Service Bulletin

Subject: Information on Duramax Flywheel Housing Seals

Models: 2010-2012 Chevrolet Express
2011-2012 Chevrolet Silverado 2500HD/3500 Series
2010-2012 GMC Savana
2011-2012 GMC Sierra 2500HD/3500 Series
Equipped with 6.6L Diesel Engine RPO LGH or LML

This bulletin is being revised to update the Parts Information. Please discard Corporate Bulletin Number 10-06-01-004A.

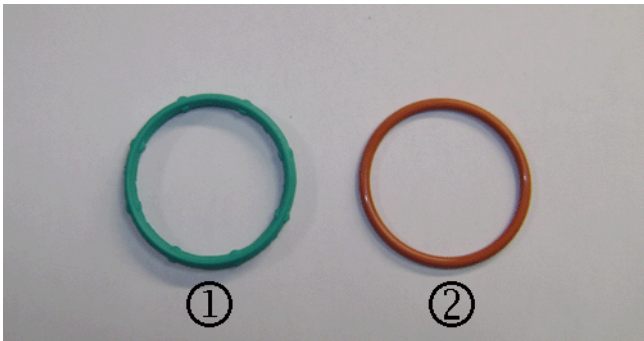
Some vehicles equipped with the Duramax™ Diesel were involved in a mid year change. Some of the vehicles may have been built with a flywheel housing that uses two different style seals; a left (2) and a right (1) one as installed.

On affected vehicles that need these seals replaced (for example; if coolant is leaking out of the rear cover), the left (as installed) seal is an orange O-ring (2), GM♦P/N♦94056175, and the right seal is a blue/green (1) press-in-place seal, GM♦P/N♦12644448.

The machining of the flywheel housing for each style of seal is different and not cross compatible. If the flywheel housing is removed for service, replace the seals with the appropriate part in the right area.
